VILLAGE OF GERMANTOWN
N112 W17001 MEQUON ROAD
GERMANTOWN, WI 53022

MEETING:	PLAN COMMISSION
DATE AND TIME:	MONDAY, AUGUST 28, 2017 6:30 p.m.
LOCATION:	Germantown Village Hall Board Room

SITE PLAN REVIEW

Plunkett Raysich Architects, agent for the Germantown School District, property owner, has submitted revised landscaping plans for the three (3) school sites for which site development and building plans were conditionally approved in May 2017, including: Germantown High School, Kennedy Middle School and County Line Elementary School.

Sheet No.:
L1.0

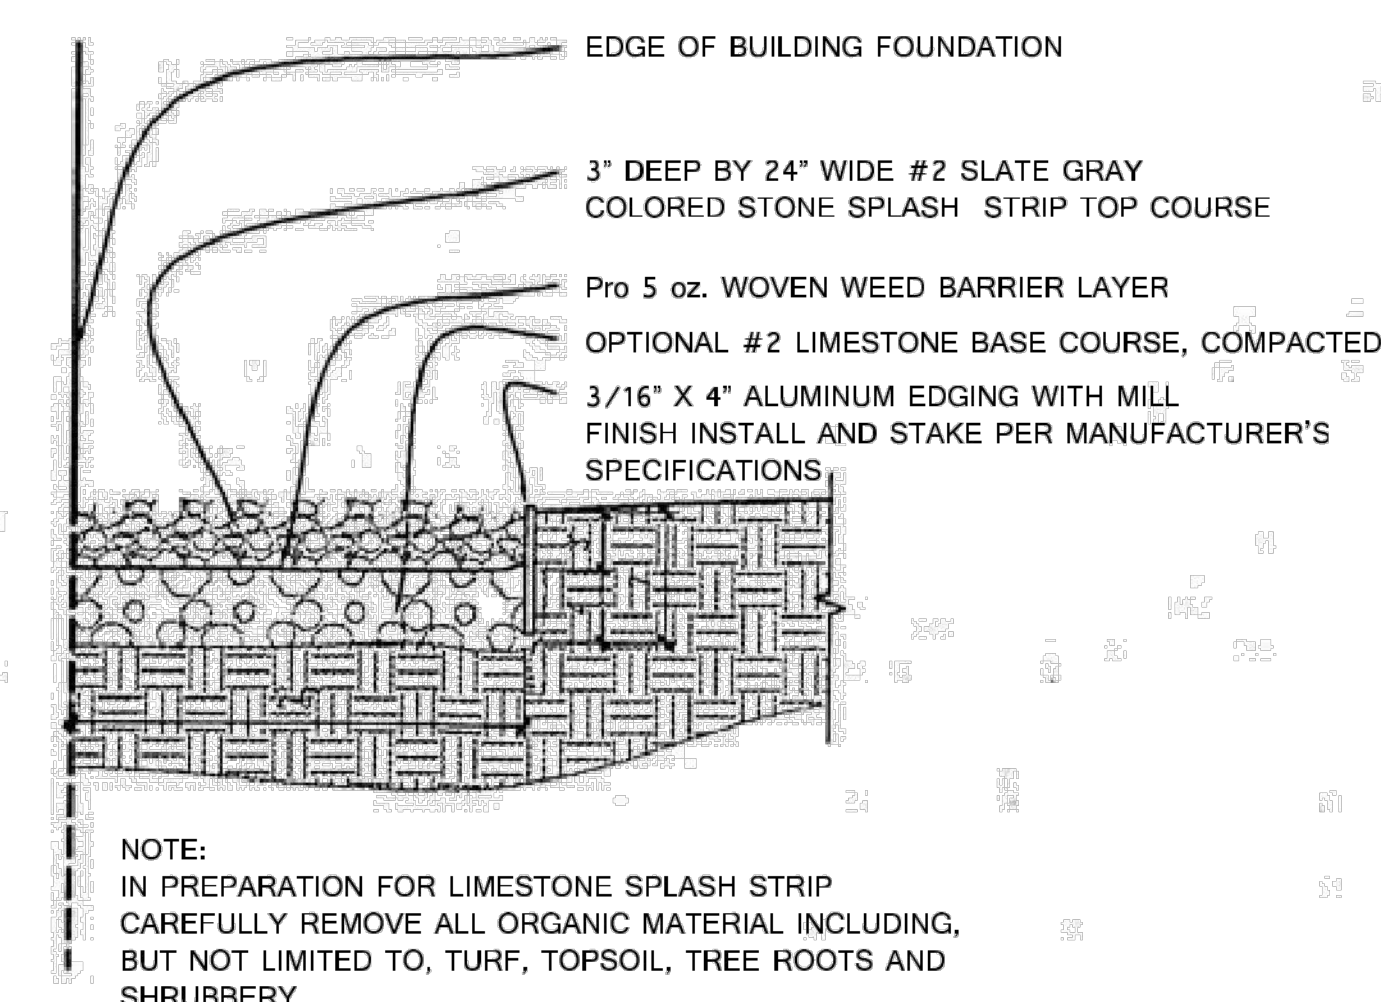
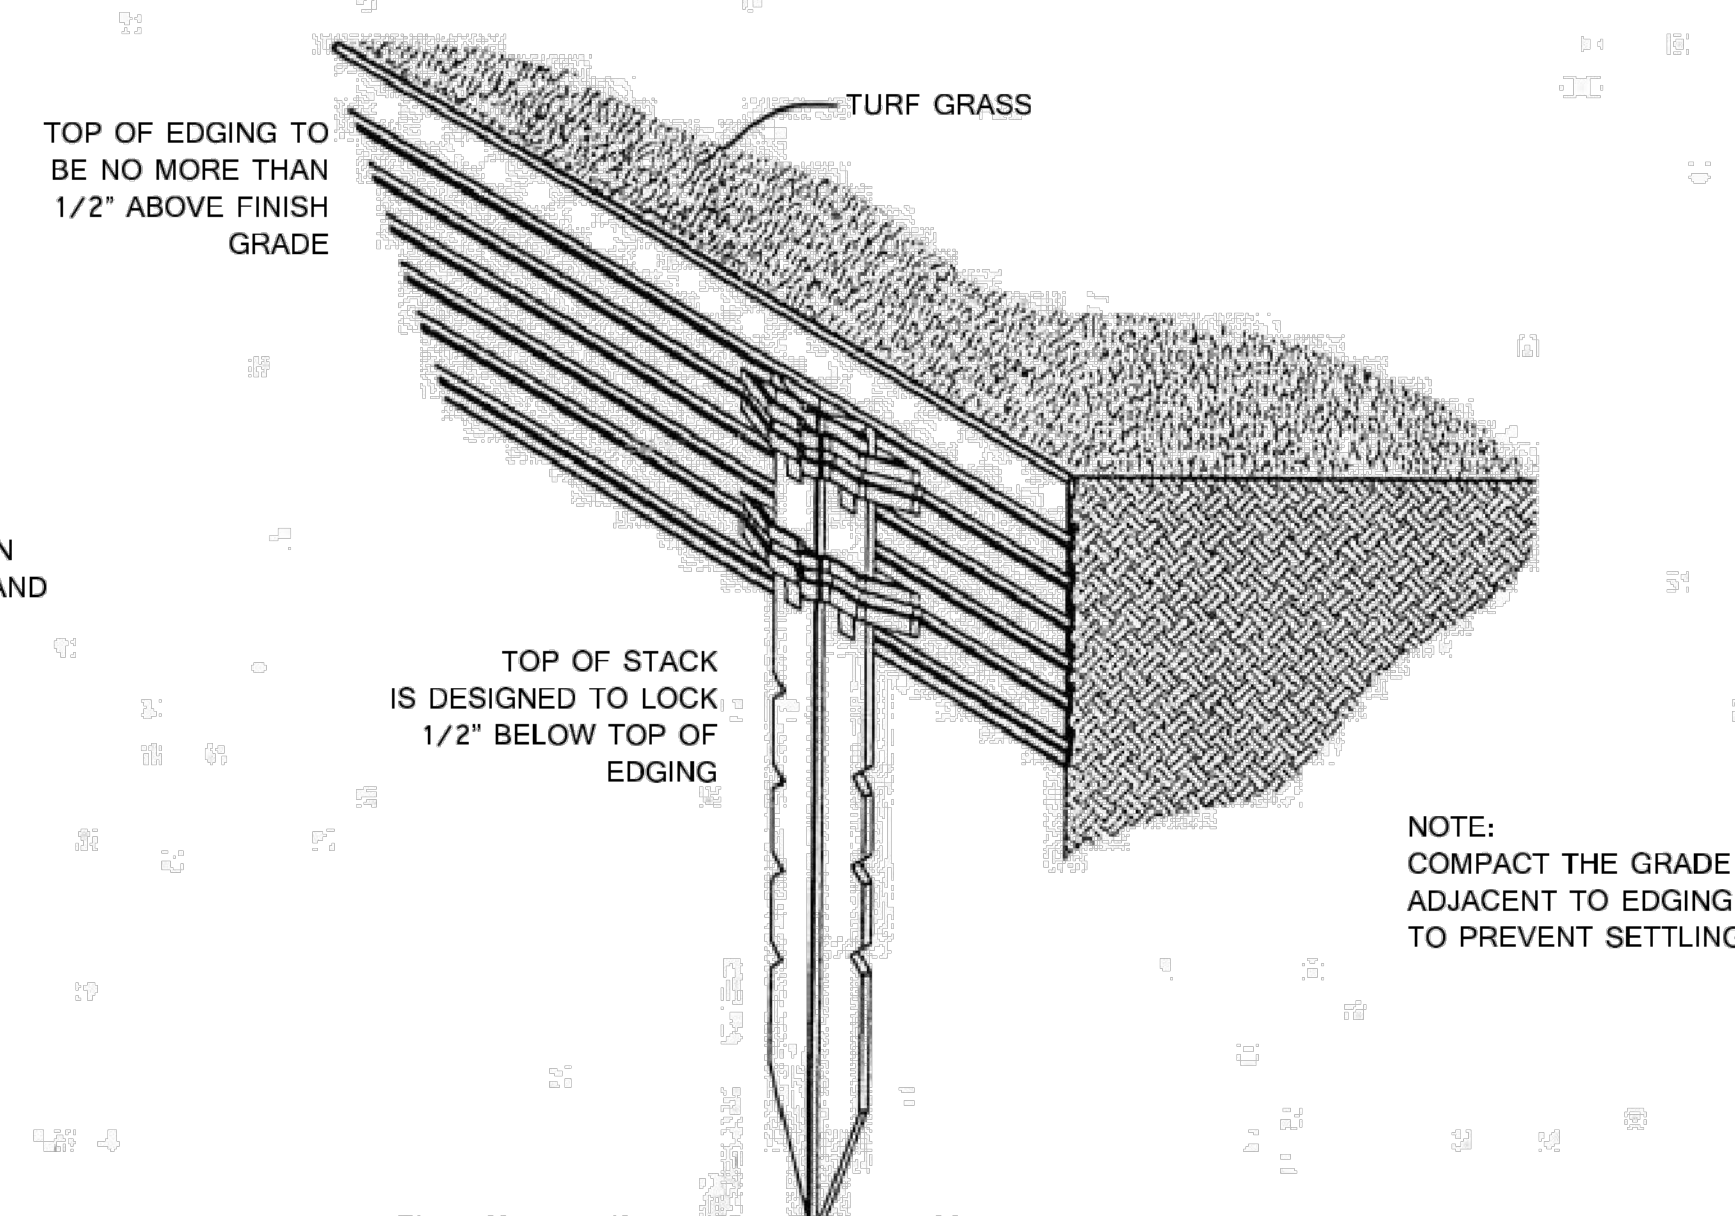
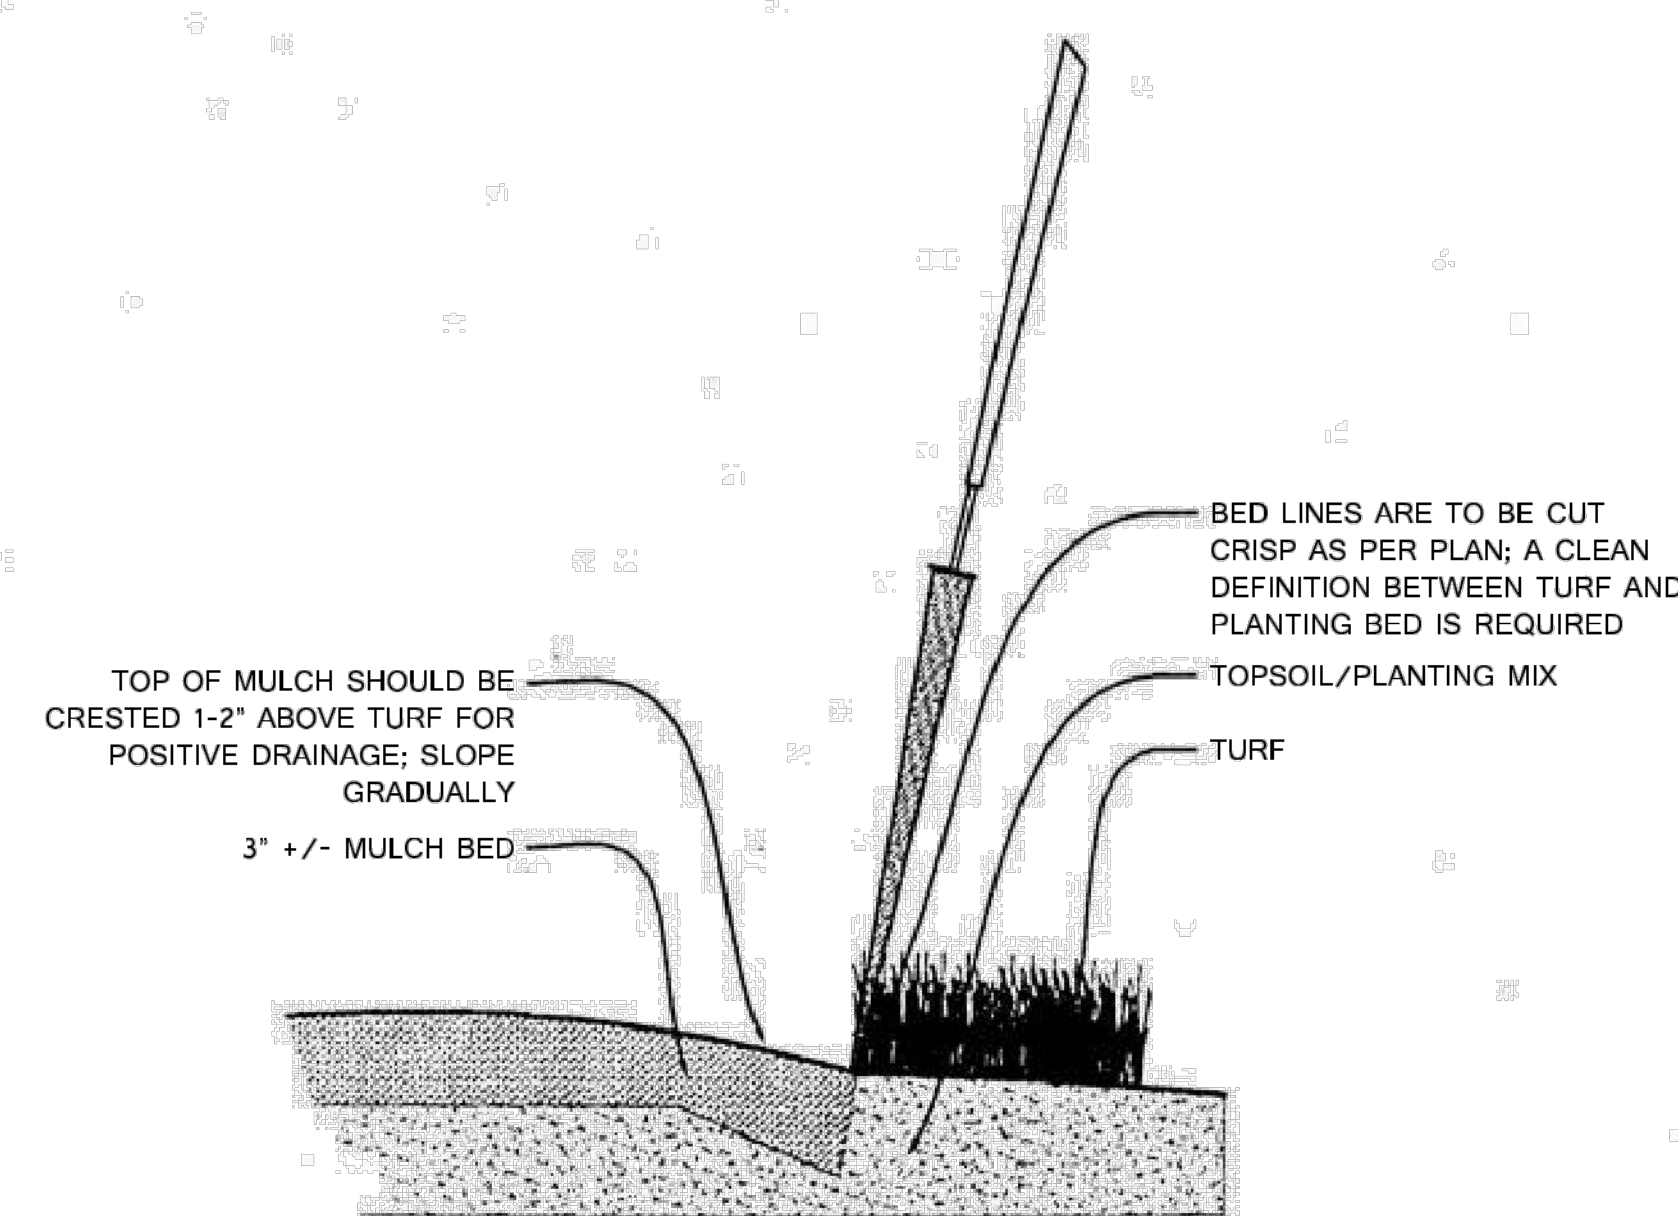
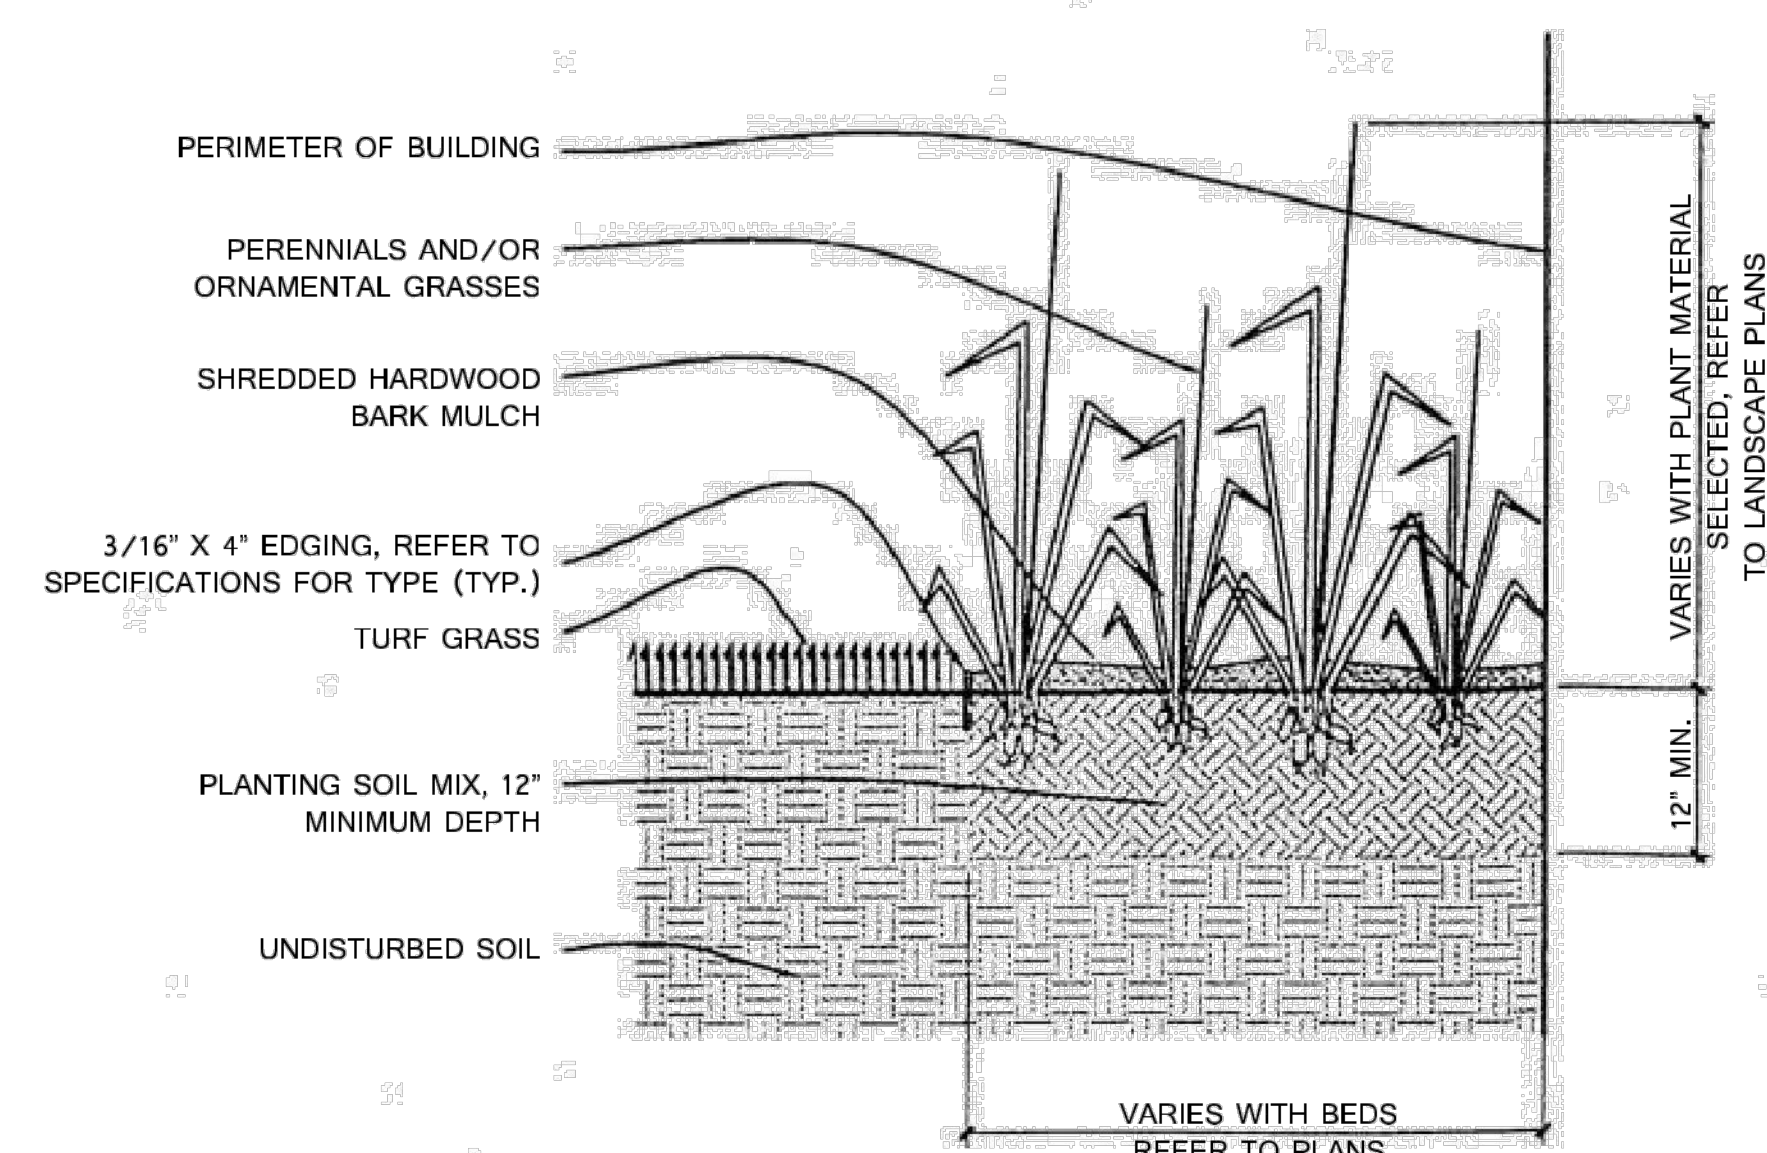
Staff continues to recommend a more substantial landscaping plan for this site given its proximity to the surrounding residential neighborhood (on all sides). As was the case

1. Install an equal number of deciduous trees on the site as compensation for the eight (8) trees being removed to make way for the parking lot in the southeast corner of the site;
2. Install additional street trees along the Butternut Road and School Road frontages in an amount equal to one (1) tree per 50 feet of road frontage in the vicinity of the classroom addition;
3. Install a continuous buffer strip of deciduous and evergreen shrubs along the east and south perimeter of the new parking area in the southeast corner of the site; and
4. Install additional foundation plantings along the west elevation of the gymnasium addition, and, along the south elevation of the classroom addition.

4. The District shall revise the proposed landscaping plan for County Line Elementary to: (a) install eight (8) deciduous trees with a minimum 3" dia on the site in the vicinity of the classroom and gymnasium additions as compensation for the trees being removed for parking lot construction; (b) install street trees along the Butternut Road and School Road frontages in an amount equal to one (1) tree per 50 feet of road frontage in the vicinity of the classroom addition; (c) install a minimum 3' wide landscaped buffer strip of deciduous and evergreen shrubs along the east and south perimeter of the new parking area; (d) install foundation plantings along the west elevation of the gymnasium addition and along the south elevation of the classroom addition.
